GRANDVIEW APARTMENTS SUBDIVISION

APPLICATION NUMBER 14 DATE May 15, 2008

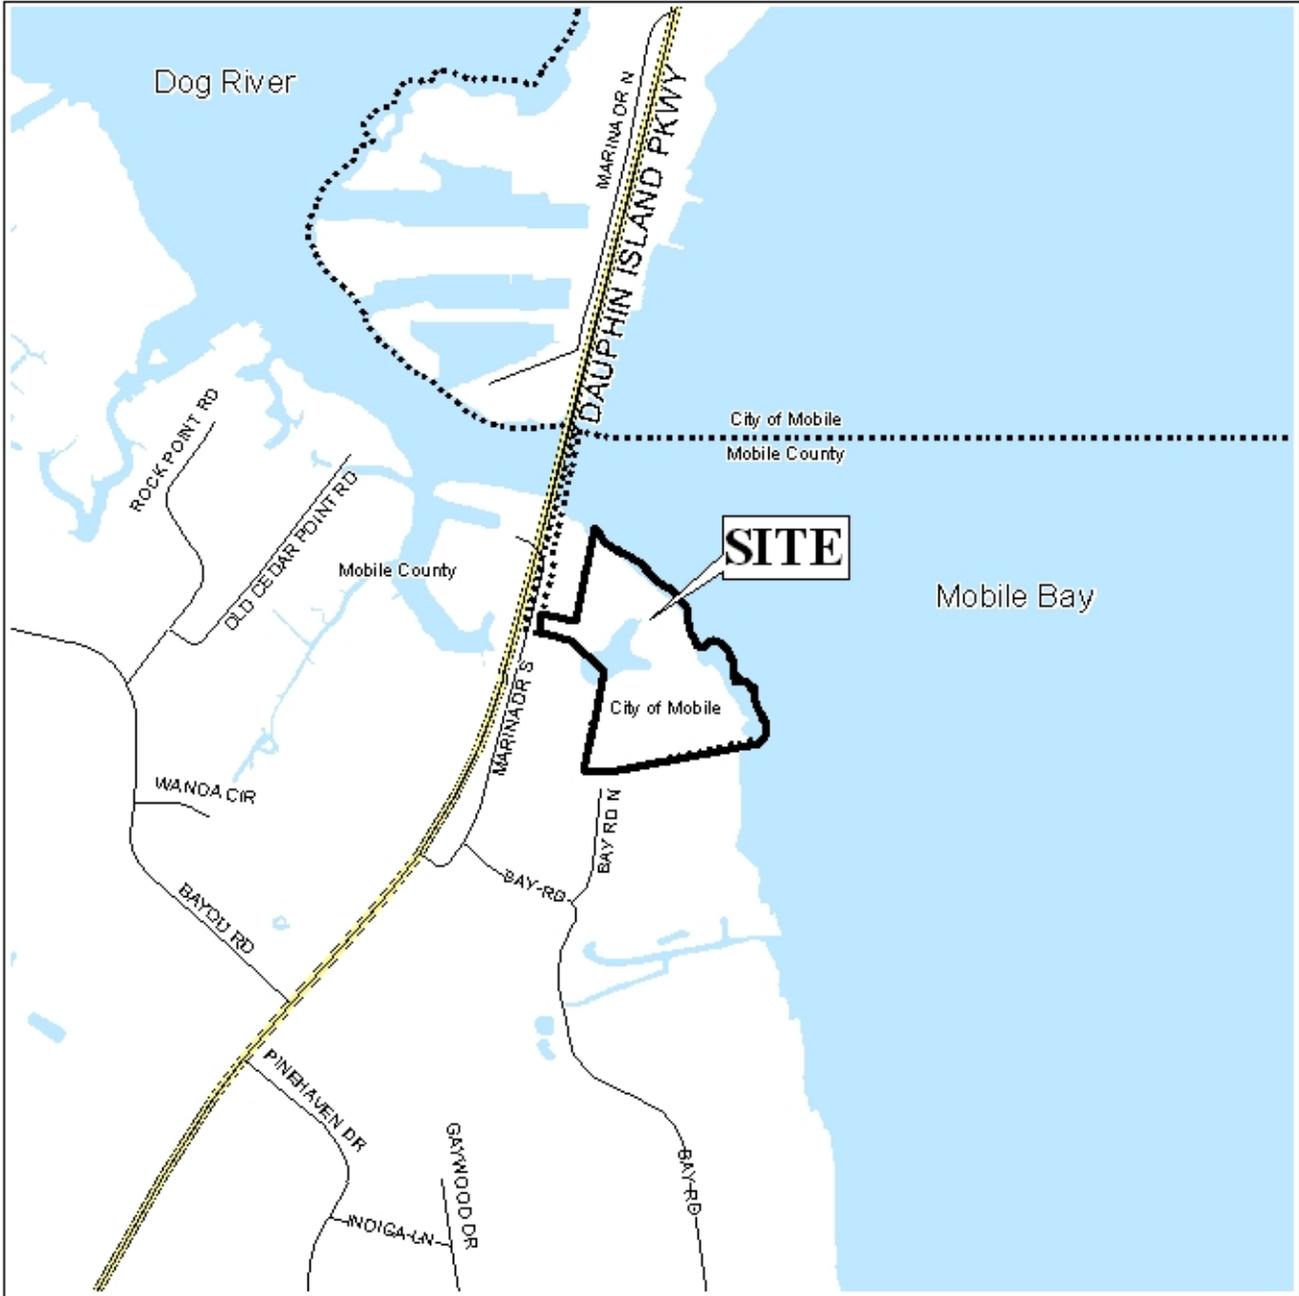
Access management is a concern for multiple reasons. First, the plat appears to propose access to Bay Road North for Lot 2. As the overall site was annexed as an apartment complex, and the development on Lot 2 is still multi-family, access to the substandard, minor residential street would not be appropriate. In fact, based on aerial photographs, the existing development appears to have never had access to Bay Road.

As indicated above, proposed Lot 2 is currently developed with multiple buildings, therefore a Planned Unit Development Application should accompany this request. Additionally, as the existing buildings are not located on the plat, it is not possible to determine if there are any setback issues as relate to the proposed lot line.

Given its location on Mobile Bay, the site would be considered environmentally sensitive; therefore, the approval of all applicable federal, state and local agencies would be required prior to the issuance of any permits or land disturbance activities. The minimum finished floor elevation should be indicated for each lot, and the flood zone(s) should be indicated on the plat, if approved.

Finally, if approved the plat should be revised to label each lot with its size in square feet.

1. revision of the plat to provide Lot 2 access to Marina Drive South;
2. provision of documentation that the proposed lot line will not create a setback violation;
3. submission of an accompanying PUD application
